APPROVED: Approval of drawings and/or procedures indicates concurrence with the information presented and does not relieve the Contractor or Fabricator of compliance with all specifications and code requirements	
APPROVED AS NOTED	X
REVISE AND RESUBMIT	
NOT REVIEWED	
Date:	9/28/17
By:	<i>[Signature]</i>
<small>This review by Stantec Consulting Services Inc. is for the sole purpose of ascertaining conformance with the general design concept. This review shall not mean that Stantec Consulting Services Inc. approves the detail design inherent in the shop drawings, responsibility for which shall remain with the Contractor. Submitting same, and such review shall not relieve the Contractor of his responsibility for errors or omissions in the shop drawing or of his responsibility for meeting all requirements of the Contract Documents. The contractor is responsible for dimensions to be confirmed and correlated at the job site, for information that pertains solely to the fabrication processes or to techniques of construction and installation and for coordination of the work of all trades.</small>

CONTRACTOR NAME & ADDRESS CCS CONSTRUCTORS 138 MUNSON AVE. MORRISVILLE, VT	PROJECT NAME & ADDR

TYP. GUARDRAIL SECTION

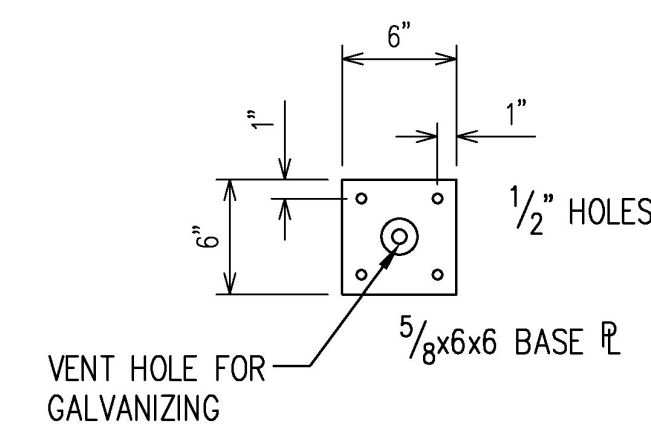
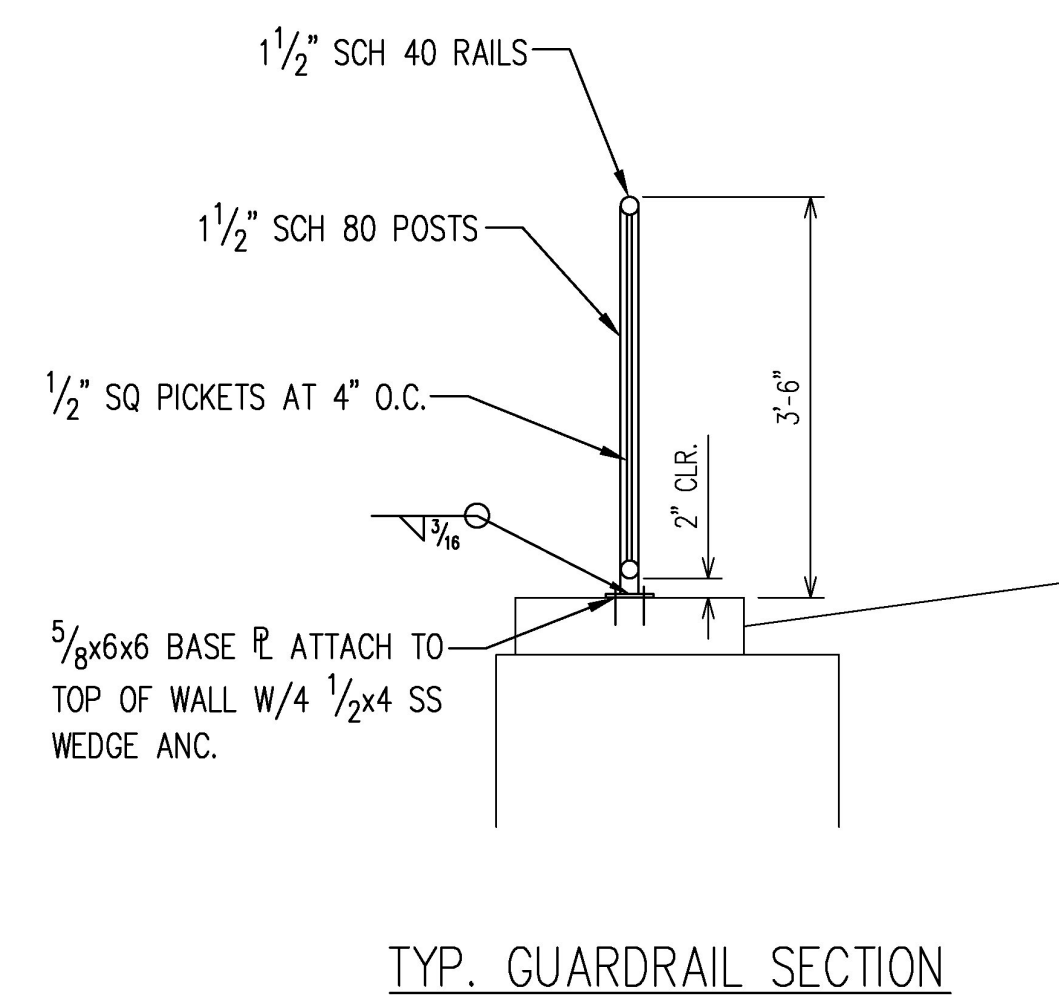
VENT RAILS FOR GALVANIZING

The welder certs. that have been re-submitted seem to be the same irrelevant certifications for FCAW. Only one of the 5 welders submitted, Silas Downen, is certified for GMAW which is the process that has been called out by DMS that will be used. All welders who weld on VTrans work, shall be certified correctly.

and Powder Coated
